## RESPONSE TO COMMENTS

### City of Burley Wastewater Treatment Plant NPDES Permit No. ID0020095 June 11, 2018

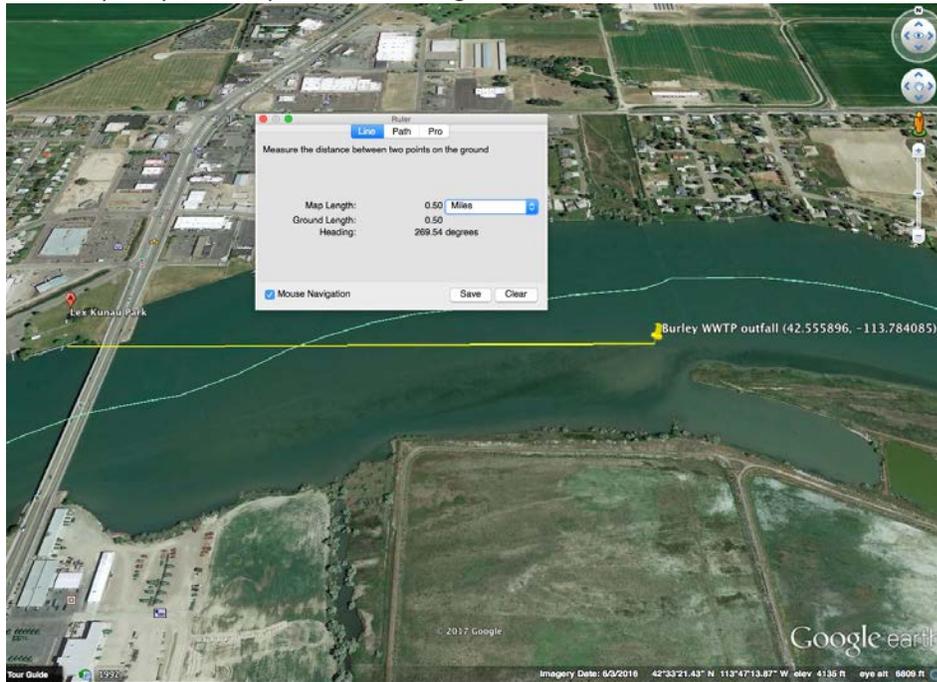
IDAPA 58.01.02.251.01.b.iii states that public swimming beaches within waters designated for primary contact recreation shall necessitate a more stringent *E. coli* single sample maximum of 235 organisms/100 mL. For this permit to satisfy Idaho water quality standards, the EPA must adopt this stricter *E. coli* limit for the Burley WWTP due to the close proximity of the plant outfall to a downstream public swimming location. As shown on the Google Earth image below, the plant discharges treated

effluent a mere half mile upstream of a swimming area at Lex Kunau Park<sup>6</sup>. This is a public park with swimming docks, a lifejacket exchange stand, and public references to swimming use online, which should qualify it as a “public swimming beach” as defined in IDAPA 58.01.02.010.81.

The EPA has reviewed the information regarding Lex Kunau Park and has determined that it meets the definition of a public swimming beach as defined in IDAPA 58.01.02.010.81 due to the features, signage, and public use as a swimming destination.

For public swimming beaches, the Idaho water quality standards include a single sample maximum of 235 CFU/100 ml. As set forth in the water quality standard, a sample count above this value should be considered in beach closures (IDAPA 58.01.02.251.01.b.iii). The EPA has included a provision in the permit that requires the permittee to notify IDEQ if a sample exceeds 235 CFU/100 ml during months when swimming is likely to occur (i.e., May – September).

Added Footnote 11 to Table 1. The permittee must notify the IDEQ within 24 hours if the single sample maximum for *E. coli* bacteria exceeds 235 CFU/100 ml during the following time period: May 1 - September 30.
